NPF-38-148

ATTACHMENT A

ATTACHMENT B

This report provides reactor coolant system pressure-temperature limits valid through twenty (20) effective full power years' (EFPY) operation for Waterford Steam Electric Station Unit 3 (Waterford Unit 3). The reactor coolant system pressure-temperature limits currently provided by the Waterford Unit 3 Technical Specifications are valid through 8 EFPY and have been revised to account for additional embrittlement of the reactor vessel beltline materials due to continued neutron irradiation. The change in the reactor vessel beltline fracture toughness properties have been estimated in accordance with Regulatory Guide 1.99 Revision 2 using a projected peak surface fluence of 2.29×10^{19} n/cm². This fluence was based on the results obtained from the W-97 surveillance capsule evaluation report. The limiting material was identified as plate M-1004-2 having adjusted reference temperatures at the 1/4t and 3/4t locations of 65.4°F and 54.0°F, respectively. The reactor coolant system pressure-temperature limits, including the revised beltline analysis, have been developed in accordance with 10 CFR 50 Appendix G requirements.

FIGURE 3.4-2

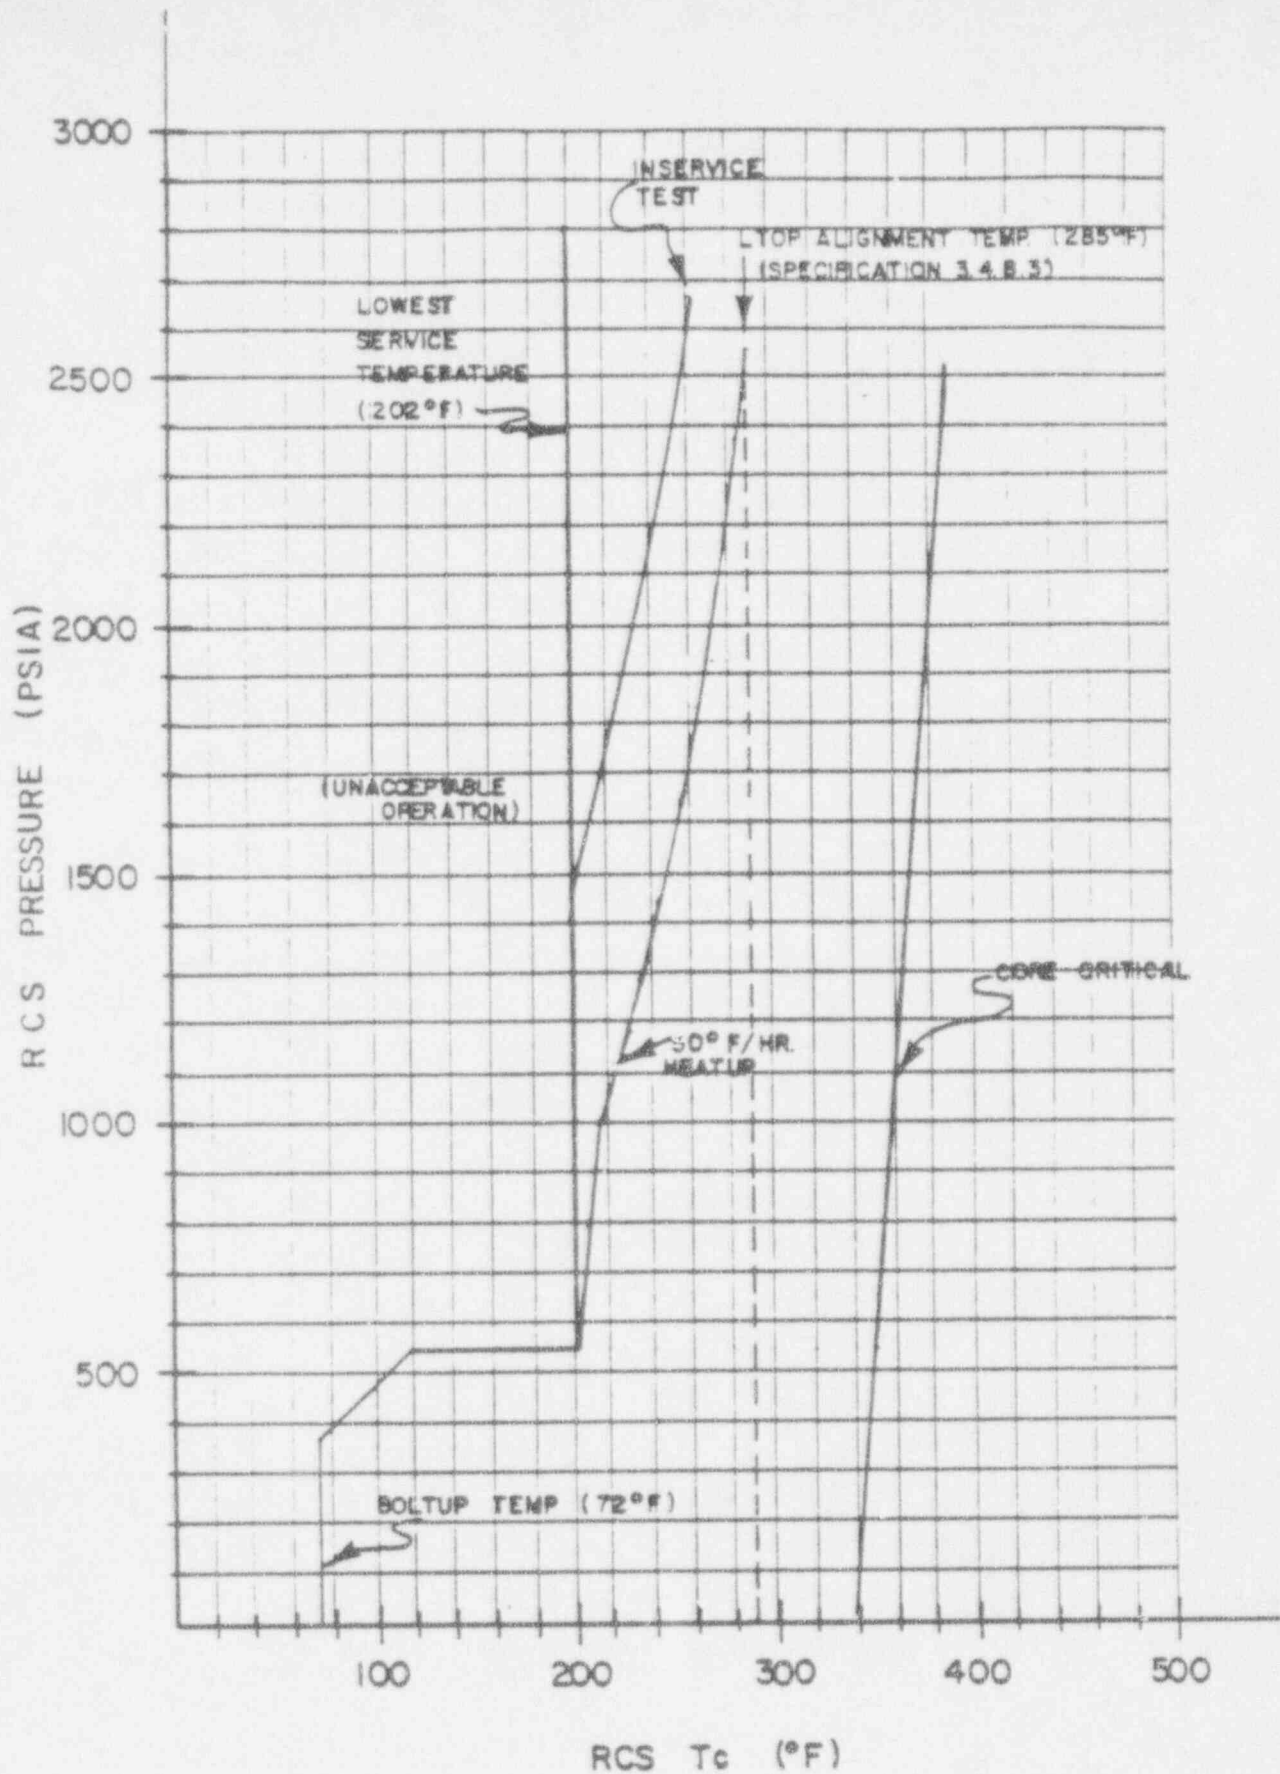
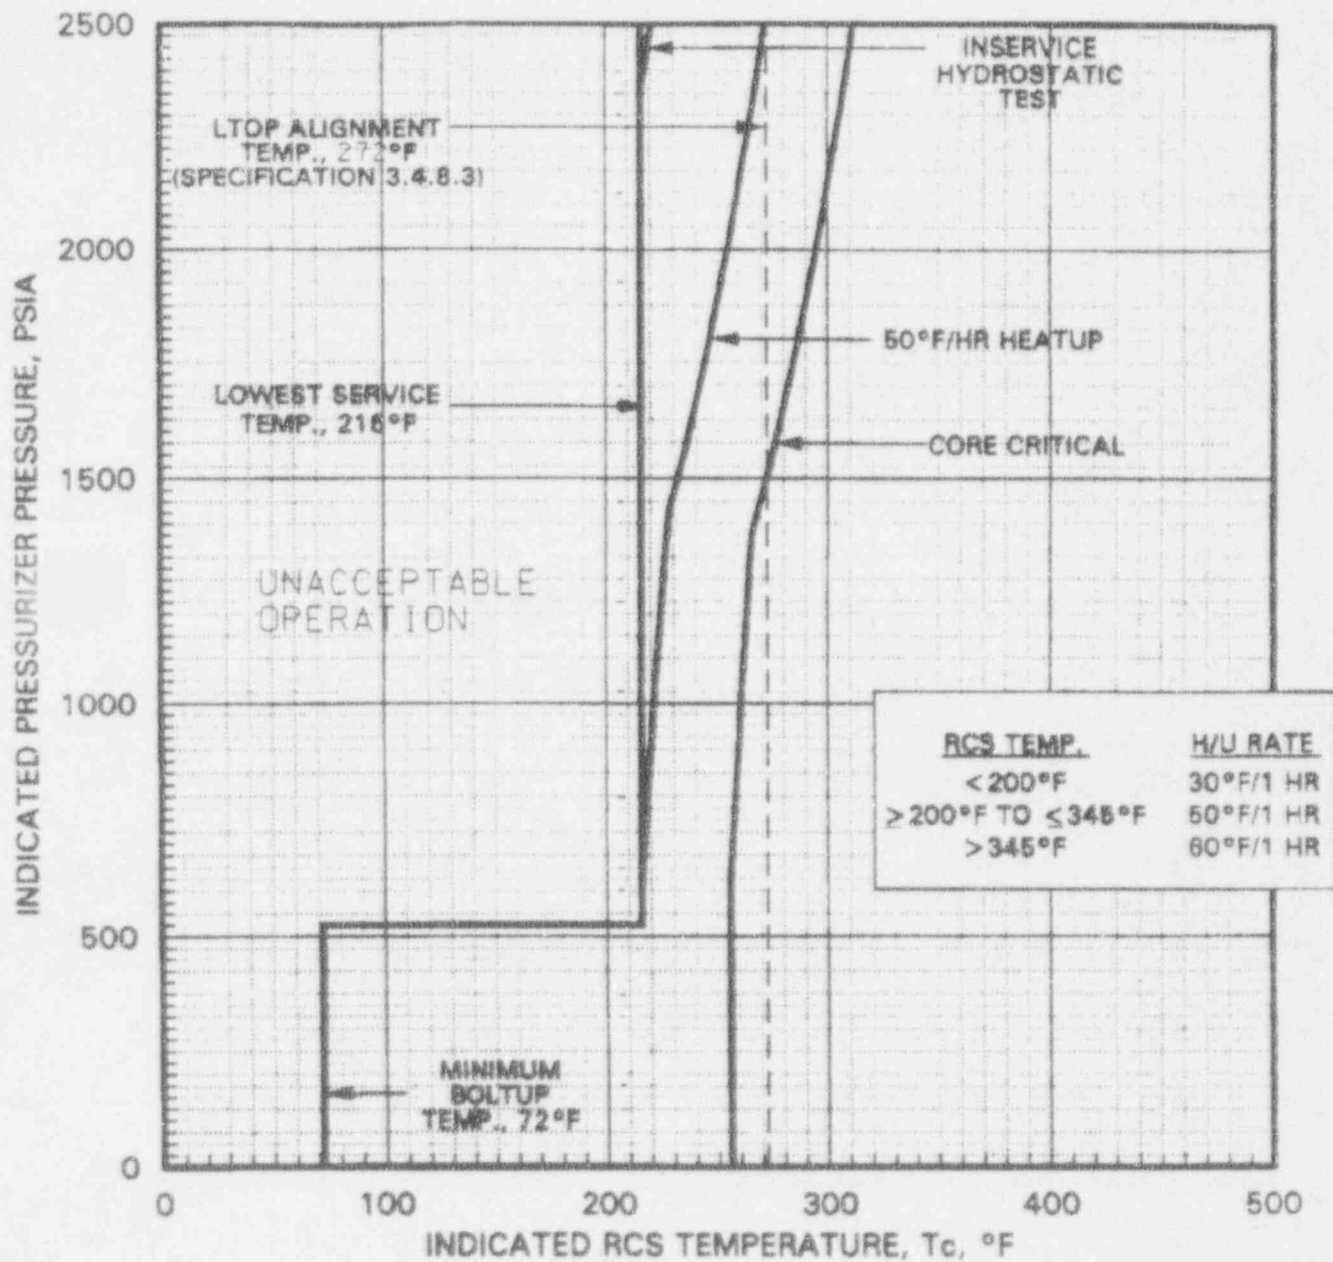
Reactor Vessel material surveillance program - withdrawal schedule in ~~Table 4.4.5~~
~~FSAR Table 5.3-10~~. The results of these examinations shall be used to
update Figures 3.4-2 and 3.4-3. The adjusted reference temperature resulting
from neutron irradiation shall be calculated based on the greater of the
following:

WATERFORD UNIT 3 HEATUP CURVE

0 - 20 EFY (PEAK SURFACE FLUENCE = $2.29 \times 10^{19} \text{ n/cm}^2$)
